DEFENSE NUCLEAR FACILITIES SAFETY BOARD

Staff Issue Report

SUBJECT: Air Pulse Agitator Controls, Salt Waste Processing Facility

Figure 1

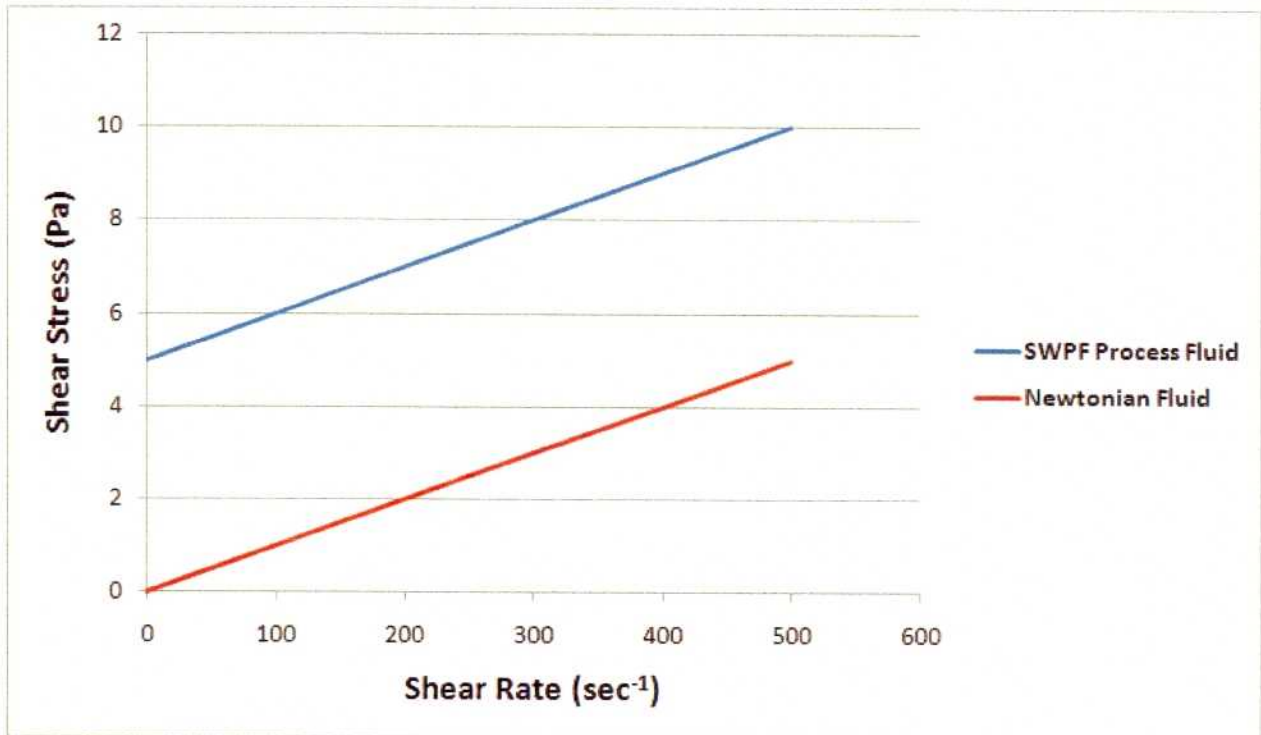
The design basis for the facility's process does not address the potential for a combination of waste sludge and monosodium titanate exhibiting thixotropic behavior after settling.⁴ The potential for this behavior is described in a study of the rheological characteristics of mixtures of monosodium titanate and sludge simulant. Failure to consider the potential for thixotropic behavior in the design of the air pulse agitators could result in the inability to fully resuspend solids following periods without agitation.
